Access Compliance Report

Public Rights-of-Way

(Curb Ramps)

Intersection ID: 12438	Main Street: E_8TH_ST	Cross Street: N_DAVIDSON_ST	Location: N
ADA ID: EF96335280AD	Ramp Type: PerpDiag	Initial Pass/Fail: Fail	Overall Compliance: No
Severity Score: 8.75			
Codes/Mitigation Info/Possible Solution		Field Measurements/Component Compliance

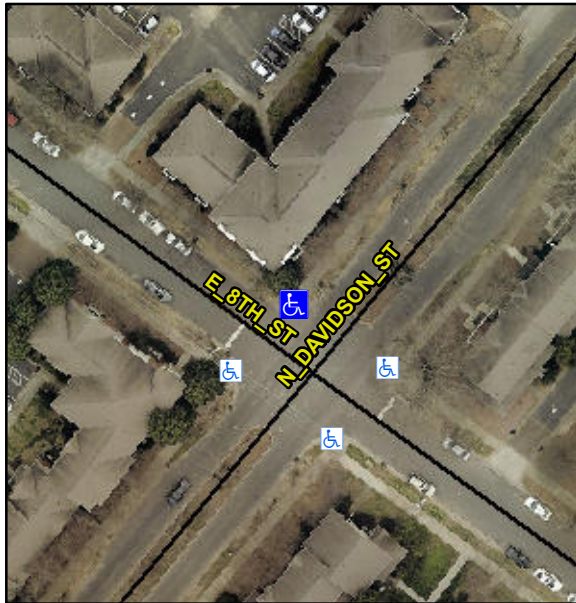
Not Found, R304.5.1

Remove & Replace Curb Ramp With Two New Directional Ramps or Equivalent.
